Subject: RE: New Tree Review Status for 2009 Lakeshore Dr. - 2016-156405 TP

Tree Ordinance Review Application

LAKE SHORE RESIDENCE
Board of Adjustments

NEW SETBACKS BY COA

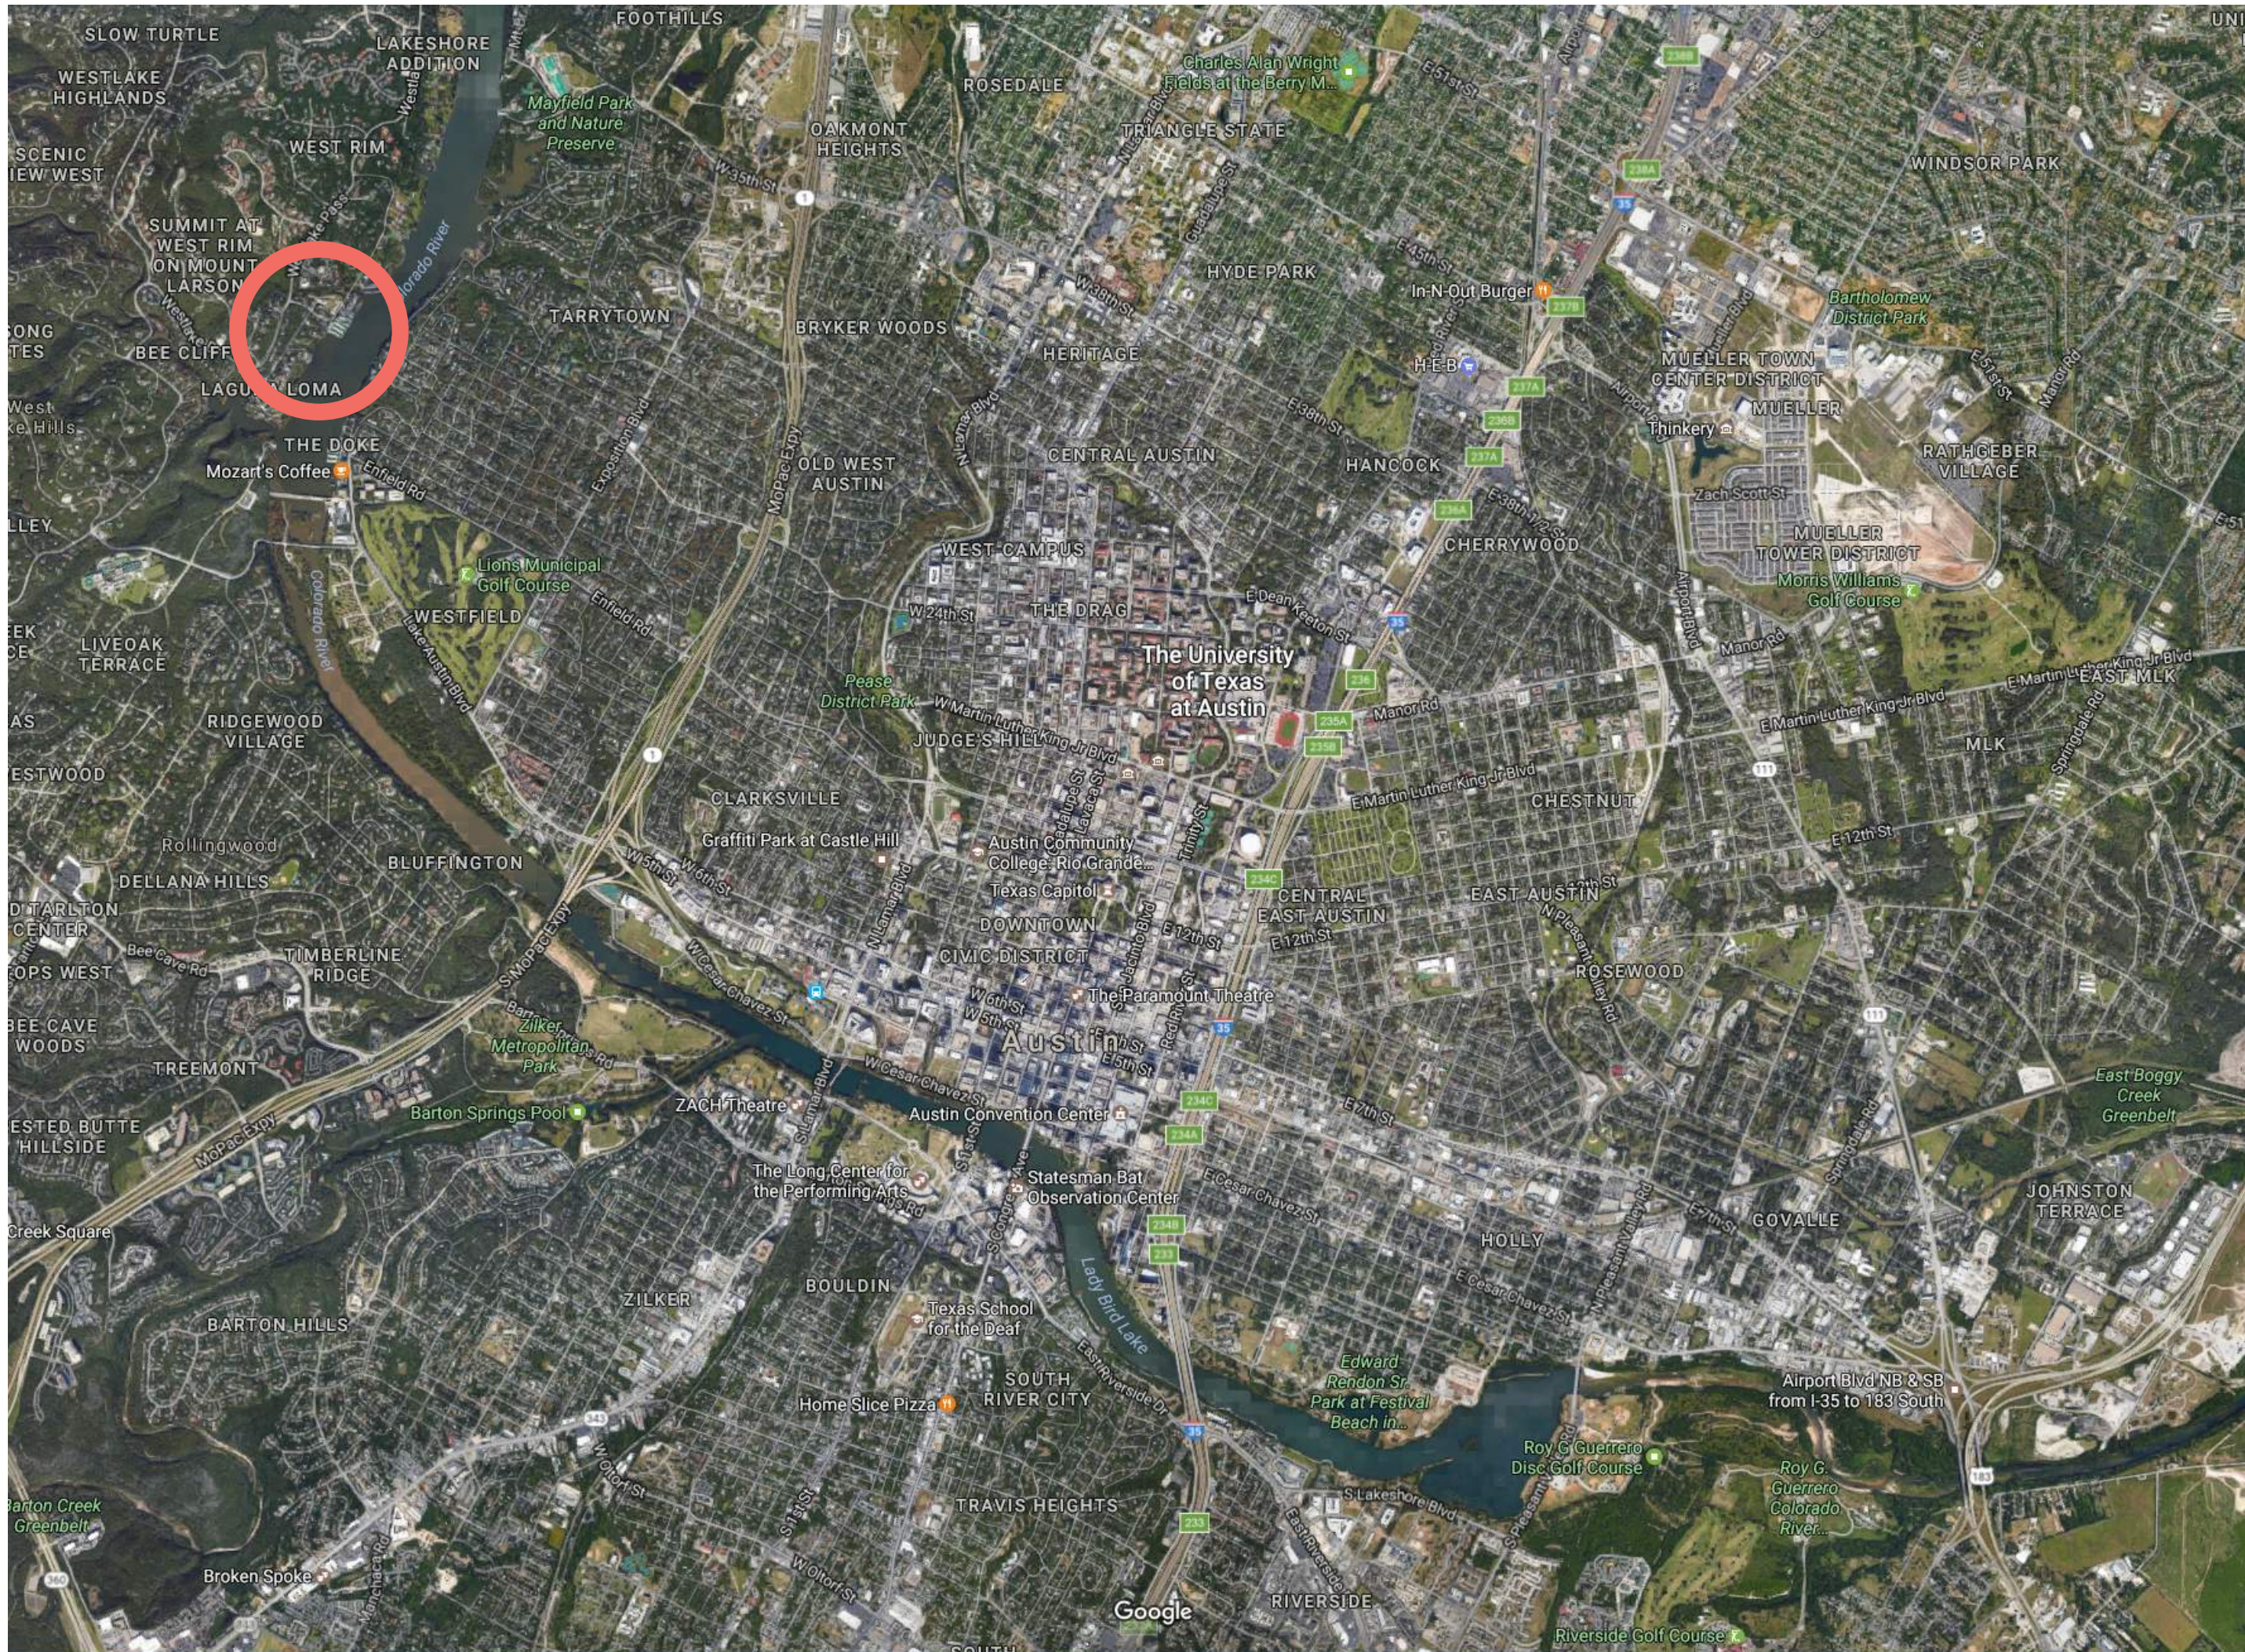
“Since the angle between L2 and the adjacent property line parallel to Island Way is $<135^\circ$, L2 is the front property line. As such, its setback is 40'. The setback from each respective street is 25'. However, with L2 being the front property line, the interior property line is then the rear property line requiring a 20' setback. If a 10' setback is desired, a BOA variance will need to be sought.”
